Access Compliance Report

Public Rights-of-Way

(Curb Ramps)

Intersection ID: 30233	Main Street: BELLS_KNOX_RD	Cross Street: LEECREST_DR	Location: W
ADA ID: 6E684510FF35	Ramp Type: PerpDiag	Initial Pass/Fail: Pass	Overall Compliance: No
Codes/Mitigation Info/Possible Solution		Field Measurements/Component Compliance	
Severity Score: 22.75

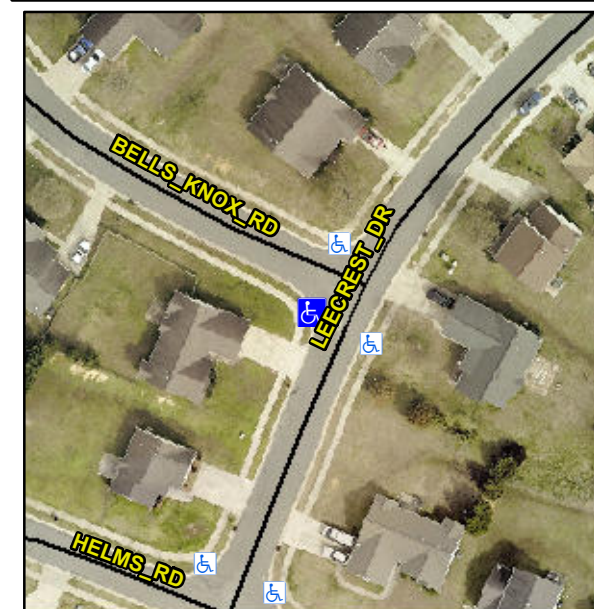
Not Found, R304.5.3, R304.2.2-Perp, R304.3.2-Para, R305, R302.7.2, R304.5.4

Compliance	Description	Data	Compliance	Description	Data
N/A	Ramp Length (in)	36.0	Yes	Ramp Slope (%)	6.0
Yes	Ramp Width (in)	48.0	No	Ramp XSlope (%)	3.8
N/A	Flare Type LT	Sloped	N/A	Flare Type RT	N/A
N/A	Flare Slope LT (%)	0.6	Yes	Flare Slope RT (%)	8.6
N/A	Flare Traversable LT?	Yes	N/A	Flare Traversable RT?	Yes
Yes	Landing Length (in)	54.0	No	DWS Provided?	No
Yes	Landing Width (in)	48.0	N/A	DWS Contrast?	No
No	Landing Slope (%)	2.2	N/A	DWS Length (in)	N/A
No	Landing X Slope (%)	5.5	N/A	DWS Full Width?	No
N/A	Landing Curb? (Y/N)	No	N/A	DWS Offset (in)	N/A
N/A	Shared Landing?	No			
Yes	Gutter Ponding?	No	No	Gutter Slope (%)	13.8
No	Gutter Lip Ht (in)	0.5	Yes	Gutter X Slope (%)	1.5
N/A	Painted X Walk1?	No	N/A	Painted X Walk2?	No
	X Walk 1 Direction	To SE		X Walk 2 Direction	To NE
N/A	X Walk 1 Width (in)	N/A	N/A	X Walk 2 Width (in)	N/A
	X Walk 1 Slope (%)	3.3		X Walk 2 Slope (%)	7.2
	X Walk 1 X Slope (%)	1.8		X Walk 2 X Slope (%)	1.6

N/A	Ramp inside XWalk1?	N/A	N/A	Ramp inside XWalk2?	N/A
	Road Slope (%)	3.7	N/A	Clear Space?	Yes
	Road X Slope (%)	7.4	N/A	Clear Space to XWalk (in)	N/A
Yes	Any Obstructions?	No	Yes	Storm Grate/Utility Hazard?	No
	Obstruction Type			Storm Grate/Utility Type	
		N/A			N/A
			Yes	Surface Condition? (G/P)	Good

Remove & Replace Curb Ramp With Two New Directional Ramps or Equivalent. Remove & Replace Gutter.
